Council assessment of Clause 4.6 request

1 Visual representation of height offset

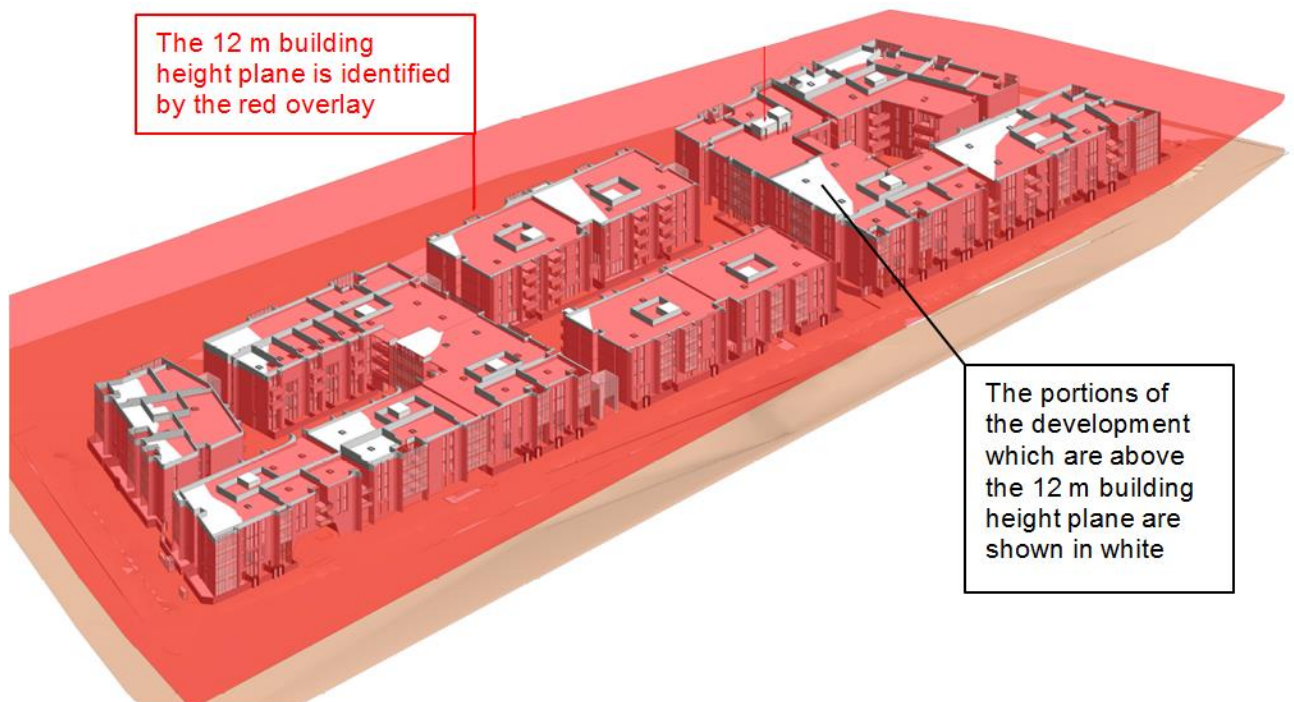
- 1.1 The following figure identifies the portions of the development that exceed the height limit and the portions of the development that are below the height limit.

The maximum height limit on the site is 12 m. Although the development exceeds the permissible height by up to 1.19 m to the parapet, 2.4 m to the plant screening structures and 3.05 m to the lift overruns, none of the components which exceed the height limit relate to habitable room area. The increase in height therefore does not impact on the density / floor area of the development.

The visual impact of the additional building height will not be visually perceptible as viewed from adjoining developments and the public domain. The additional height simply accommodates the roof structure and rooftop services.

The additional shadow impacts do not impact on any surrounding land given the new public roads around the perimeter of the development site. The overshadowing caused by the non-compliance is due to the rooftop parapets and plant and equipment which is captured within the roof space itself.

Based on the above assessment, the requested variation under Clause 4.6 is considered reasonable, well founded and is recommended for support.
